23329 Frederick Rd. HPC#13/10-03C
Clarksburg Historic District

HISTORIC PRESERVATION COMMISSION STAFF REPORT

Address:	23329 Frederick Road, Clarksburg	Meeting Date:	10/22/03
Resource:	Contributing Resource Clarksburg Historic District	Report Date:	10/15/03
Review:	HAWP	Public Notice:	10/08/03
Case Number:	13/10-03C RETROACTIVE (partial)	Tax Credit:	None
Applicant:	Arric Rudden	Staff:	Anne Fothergill

PROPOSAL: Sign, lighting, and siding installation

front box sign to be removed

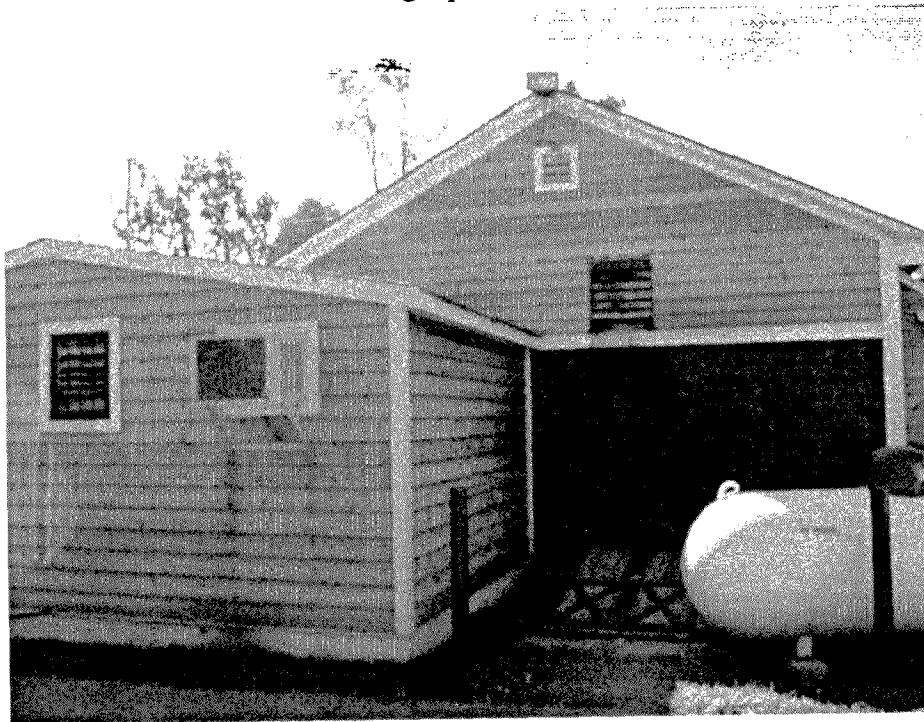
- Removal of three signs—one on the front and one on each side of the building
- Removal of the top-mount flood light currently above the new sign
- Installation of two top-mount gooseneck metal dome drop down lights above the new sign (See Circle 16 for picture)
- Installation of 5 side-mount gooseneck metal domed drop down lights—1 on the front of the building and 2 on each side

As for the additional work proposed, staff also recommends approval. The proposed new lighting fixtures are compatible with the District and are all sited in appropriate places that will not detract from the store or the District and they can be removed later if desired. Additionally, the removal of the 3 box signs also will not harm the building or District. In fact, these changes may be an

new cedar siding on side as seen from Frederick Road

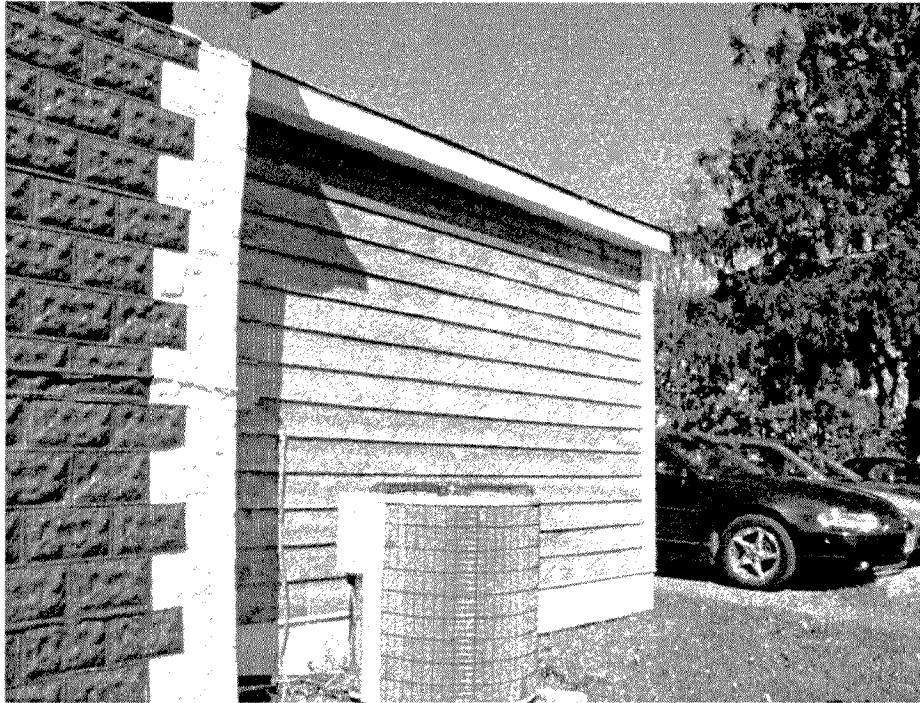
In terms of the siding installation at the back of the building, the cedar siding is actually covering up the T-111 underneath, the applicant did not remove the T-111. The two side bumpouts with the new siding are visible from the street but the horizontal cedar boards are compatible with the District and do not adversely affect the streetscape. The rear gable's corrugated metal had been installed as a patch and it also is still underneath the new boards. The cedar boards are an improvement on the previous materials. Staff again recommends approval of these alterations.

right side of building including new sign with flood light to be removed, box sign to be removed, and new cedar siding as seen from Frederick Road

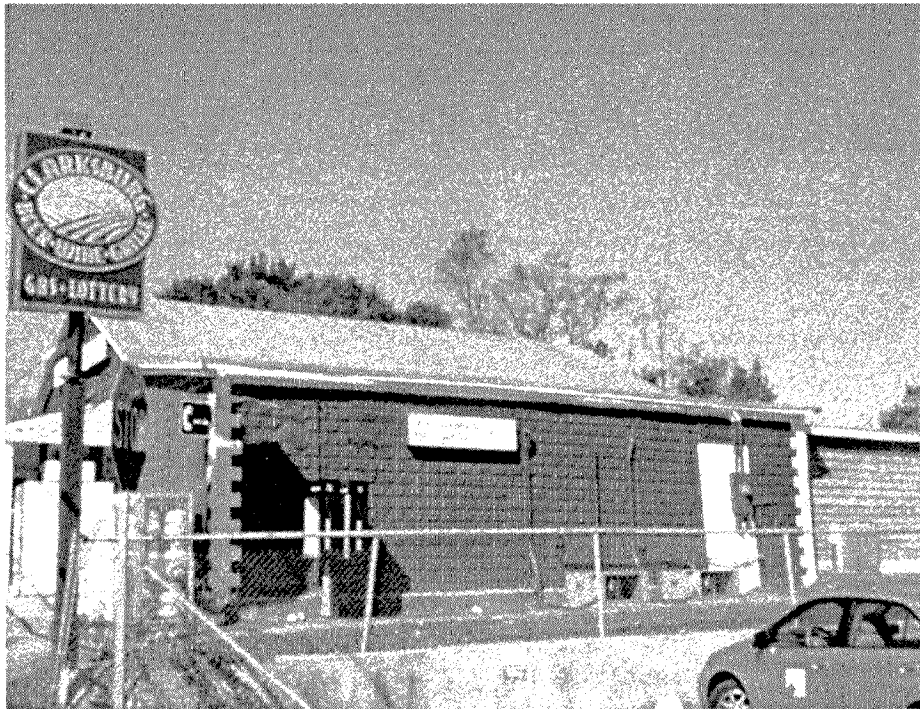
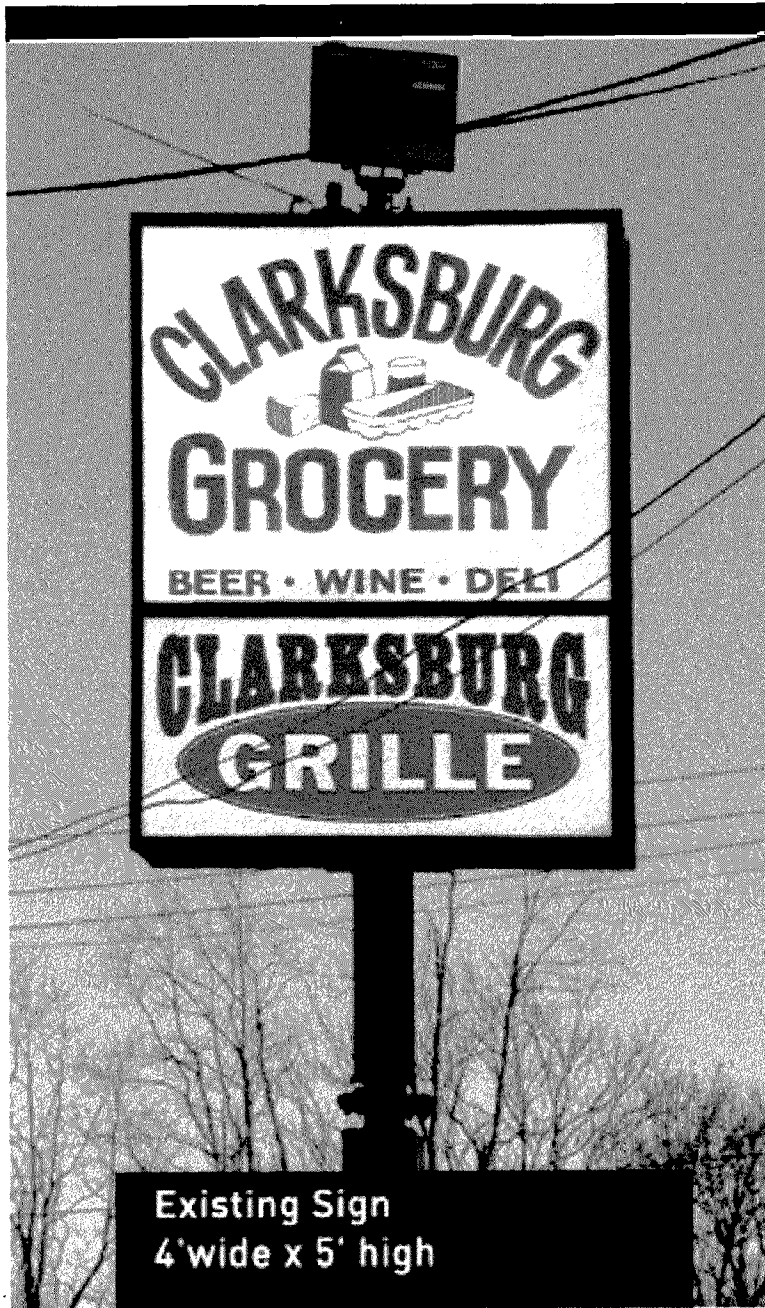
- Covered the existing front sign (see Circle **13**) with sign foam and painted new graphics on the old sign
- Covered the T-111 at the rear and back sides of the building with cedar siding (see Circles **11 + 18**)
- Covered the corrugated metal in the rear gable with cedar siding

Since there already was a sign on the sign post in front of the store and the applicant only covered the old sign and painted new graphics on top of it but did not increase the size of the sign, staff recommends its approval.
